In the Matter of Duke Energy Kentucky,)
Inc.'s Integrated Resource Plan) Case No. 2021-00245
)

**PETITION OF DUKE ENERGY KENTUCKY, INC.
FOR CONFIDENTIAL TREATMENT OF INFORMATION
CONTAINED IN ITS RESPONSES TO COMMISSION STAFF'S
AND SIERRA CLUB'S FIRST SET OF DATA REQUESTS**

Duke Energy Kentucky
Case No. 2021-00245
STAFF First Set Data Requests
Date Received: October 1, 2021

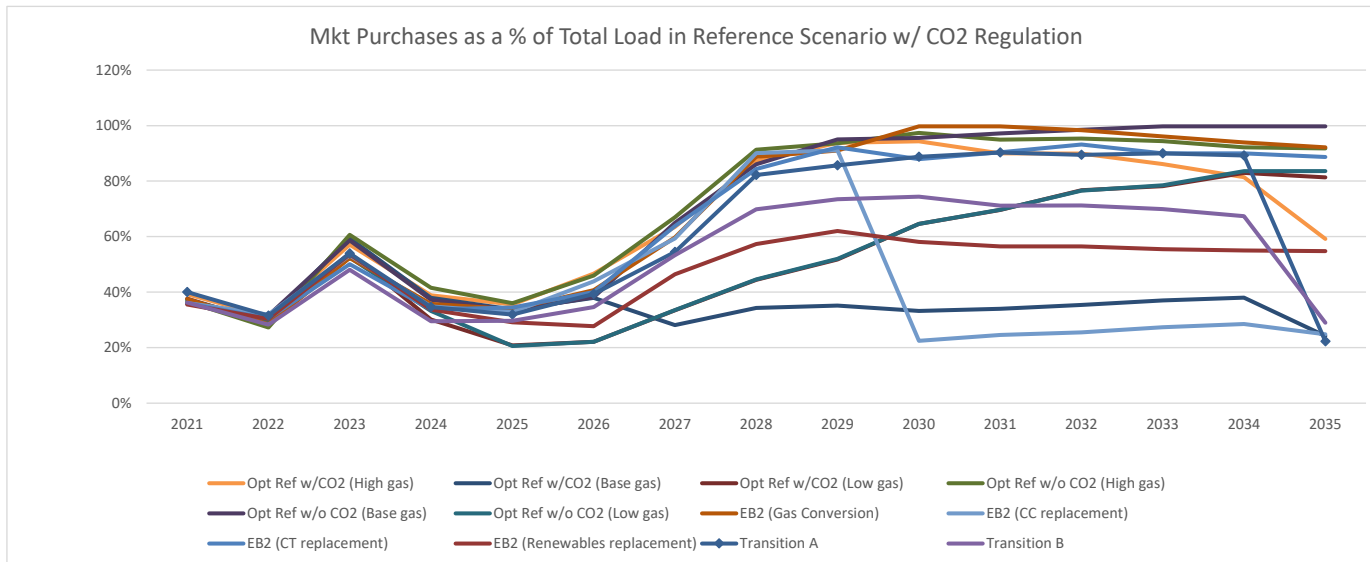
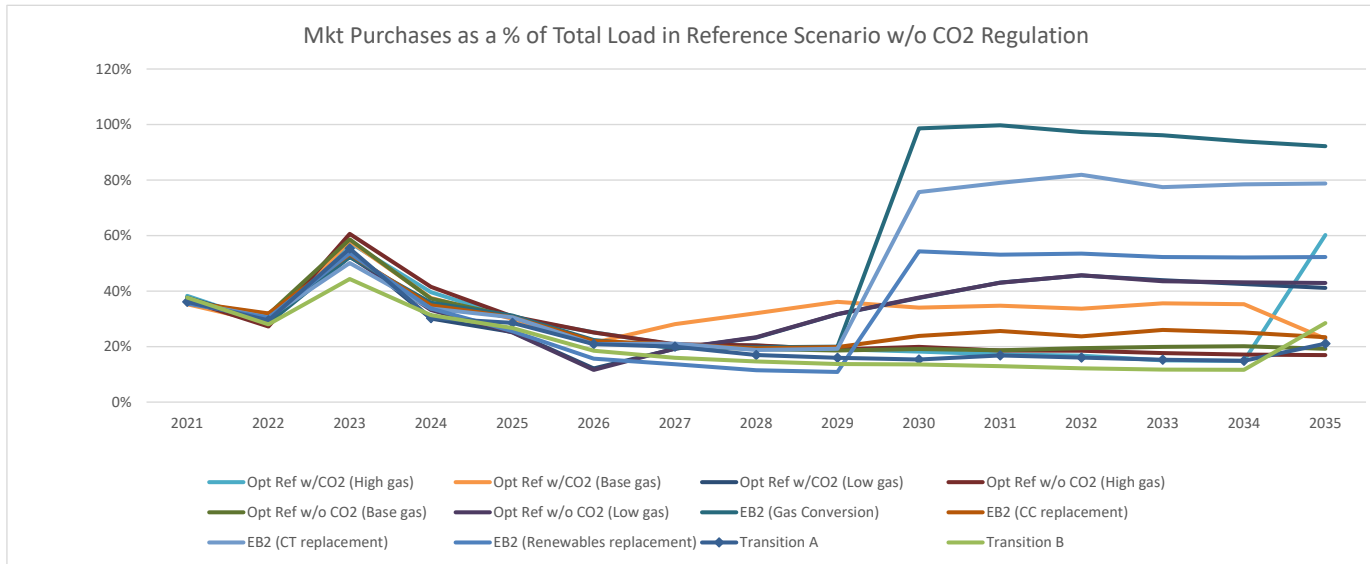
- a. Given how close Market Purchases as percent of Total Load are for the portfolios plotted in Figure 6.7, provide a chart that shows the numerical values.
- b. Explain whether a similar analysis was performed with the Low, High, and Base Gas Price cases.

- a. Please see STAFF-DR-01-022(a) Attachment. Figure 6.7 shows carbon reduction for all of the portfolios. Figure 6.8 shows market purchases. The vertical axis is divided such that the level of market purchases can be seen for each portfolio and is within a reasonable level of variability in these metrics due to changes in load, unit performance, gas and power prices.
- b. The IRP did not include data on the portfolio performance in the high and low gas scenarios. The charts that show portfolio performance in the Reference cases with and without CO2 regulation assume the base gas forecast.
